Project
Castlewood House

Drawing Title
**General Arrangement
 Roof Level Plan**

Non Material Amendment

Project No.	Drawing No.	Revision
15023	A_P_111	01

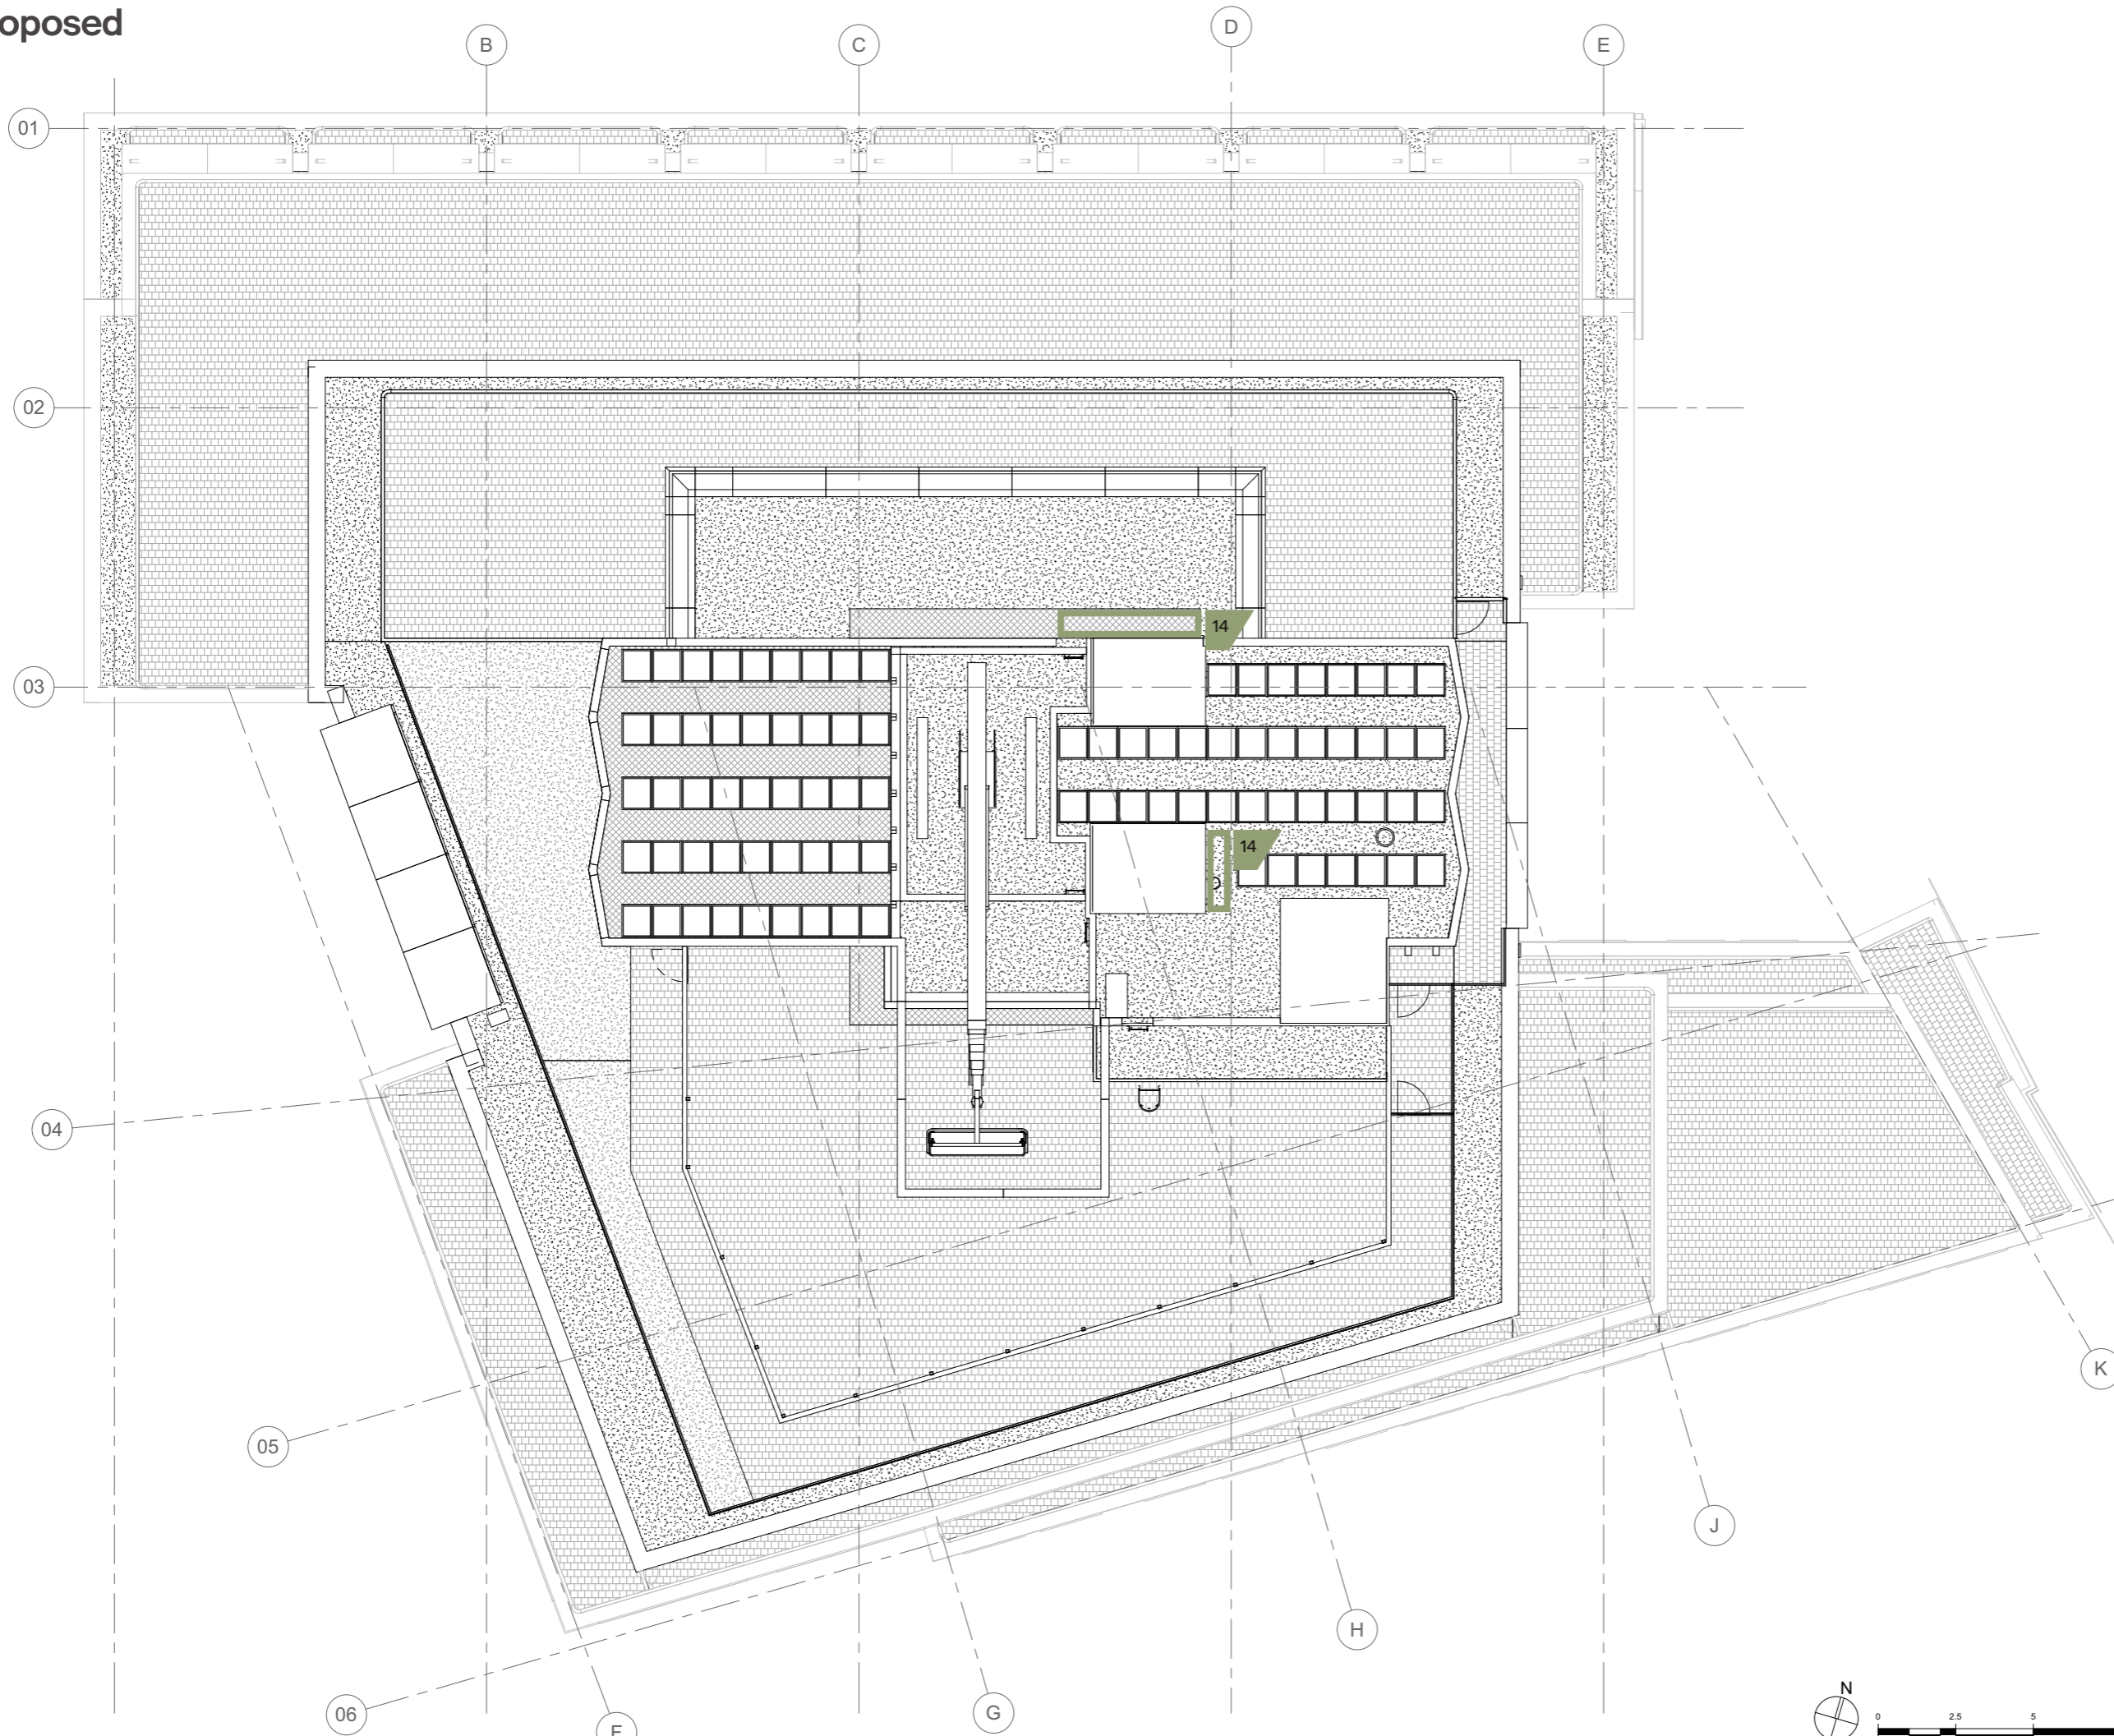
01. Attenuation tank added and blue roof omitted
02. One no. entrance lobby pass door omitted
03. Glazed corners of retail frontage amended
04. Doors added to retail unit

05. Loading bay layout reconfigured
06. Wall separating cyclist entrance omitted to provide improved user & visitor experience.
07. Minor enhancement to the entrance to comply with WELL requirements.

08. Size of the ventilation void from B1 reduced providing more space for public plaza.
09. Corner between Toni & Guy Building and Bucknall Street Warehouse Building infilled to rationalise and improve buildability.

10. Window layout rationalised and amended to follow arrangement of windows on levels below.
11. Glazing size increased to improve daylight levels into common area.

12. Lobby in front of the goods lift introduced - Roof level sits below the plant screen - no impact on elevations.
13. BOH glass balustrade changed to metal balustrade to follow the general architectural language of the building.

14. Rearrangement of risers and ducts terminating at roof level due to the M&E design development - no major visual impact.
15. Louvre zone size reduced and clad with extended decorative metal balustrade.

16. Precast spandrels span reduced to single bay.
17. Louvres introduced to the top of Bucknall Street's Retail entrance.
18. Screening detail developed as per planning condition.

19. Louvres introduced to Bucknall Street elevation for UKPN vent extracts.
